TECHNICAL SERVICE BULLETIN

ISSUE DATE:	2-22-2022
SERVICE BULLETIN SUBJECT:	35 Foot 800 Volt Accelerator Pedal Overlay Harness Retrofit
VINs or MODELS AFFECTED:	Service Specified Buses
COMPLETE BY:	Next Service Opportunity
SERVICE BULLETIN #:	SC-22-16
LABOR OPERATION CODE:	DE45Z

35 FOOT 800 VOLT ACCELERATOR PEDAL OVERLAY HARNESS RETROFIT

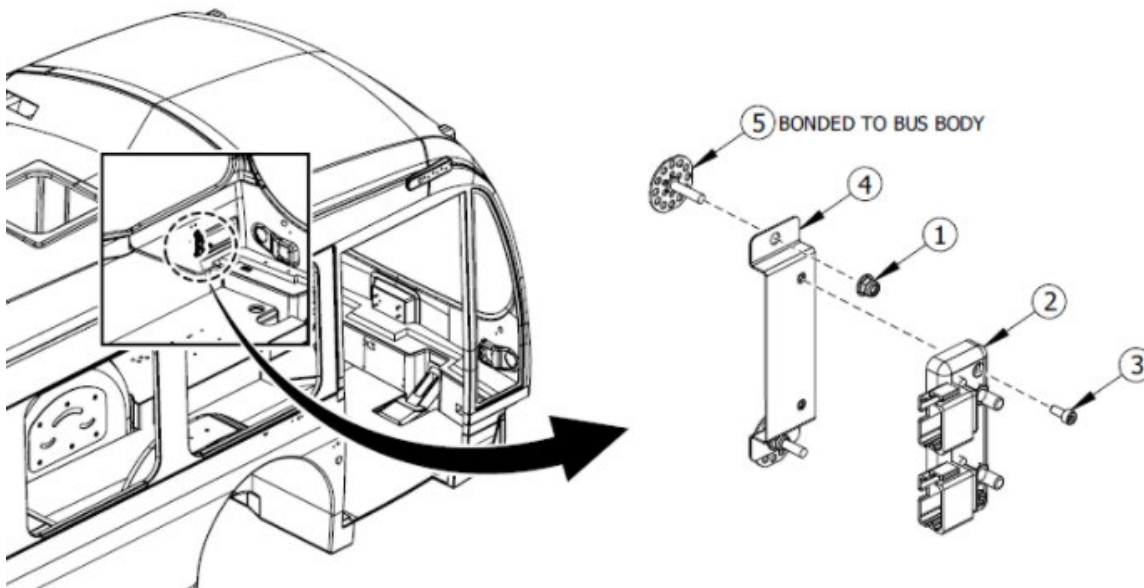
1. Complete the Proterra approved Lockout/Tagout procedure to make the bus safe for work.
2. Working underneath the Steering Wheel, locate and disconnect the Connectors labeled JD082 and JD083.

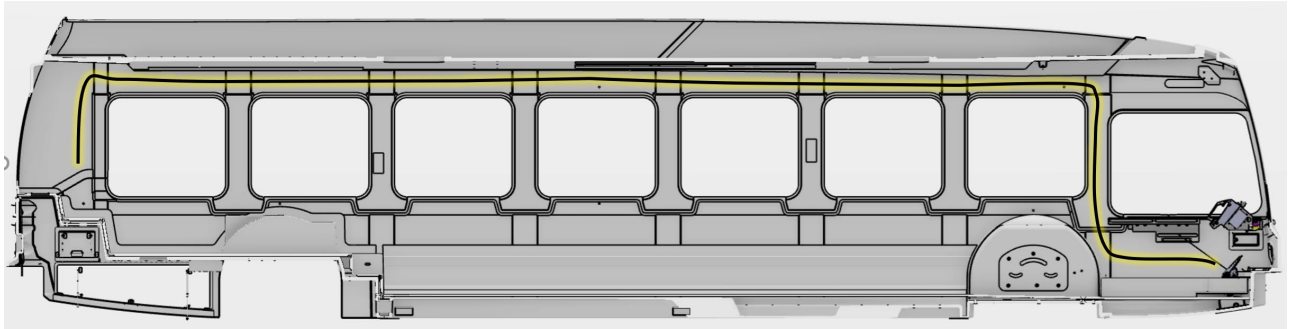
3. Using a 10mm Ratchet/Socket, remove the Ground Lug from Ground Block GDD002 underneath the dash. Retain the Washer and Nut to use later. The Ground Block is shown below in the Parts Manual View.

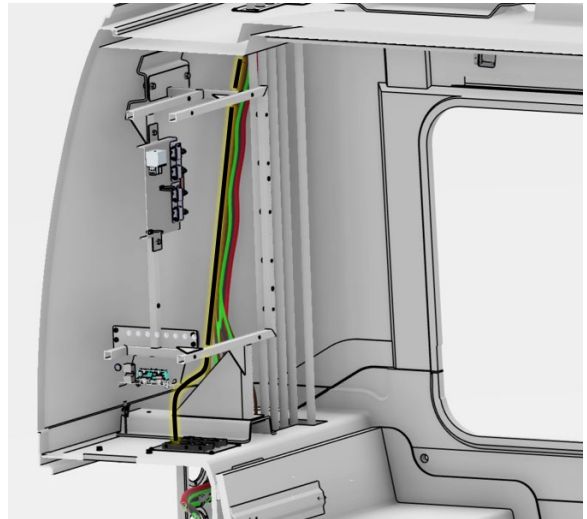
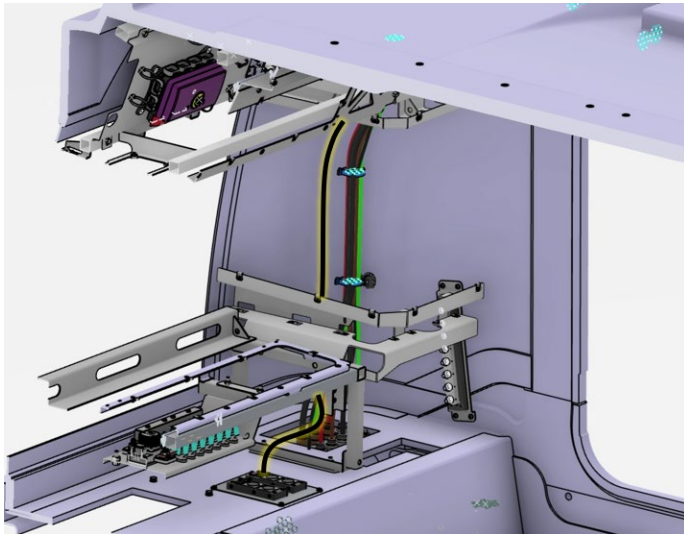
12. Working inside the bus at the streetside rear, remove any panels necessary to route the new Harness (136-6794) down through the rear deck of the bus as shown in one of the following illustrations. The illustration on the left is a current ZX5 Bus. The illustration on the right represents earlier models.

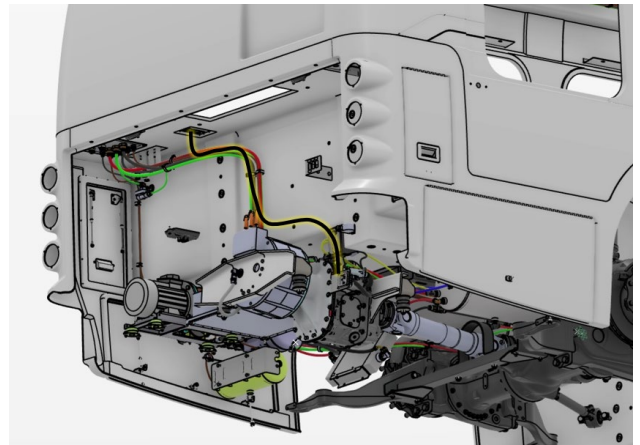
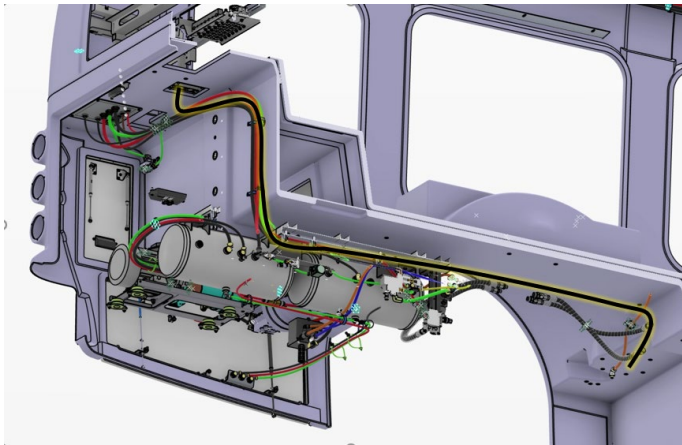
16. Route the free end of the new Harness (136-6794) as shown highlighted in yellow in the one of the following illustrations. The illustration on the left is a current ZX5 Bus. The illustration on the right represents earlier models. The Harness should be routed with the Air Lines and Low-Voltage cables. If the Harness must cross High-Voltage cables, it must cross them at right angles.

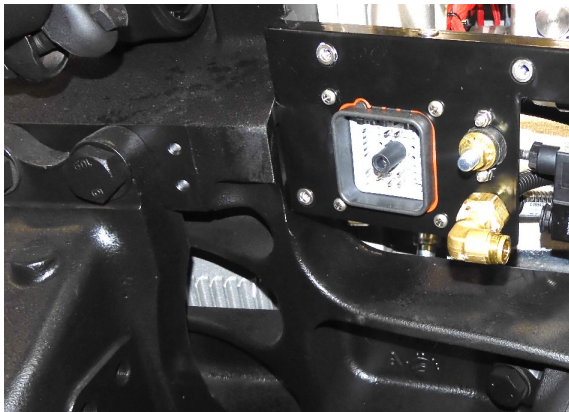
17. Locate the connector labeled PM152 on the Drive and disconnect it.

18. Using a Pin Extractor, remove the terminals installed into Cavities 37, 28, 39, and 40.

19. Install the terminals on the new Harness (136-6794) into their respective Cavities on PM152. The terminals are labeled for the proper Cavities.
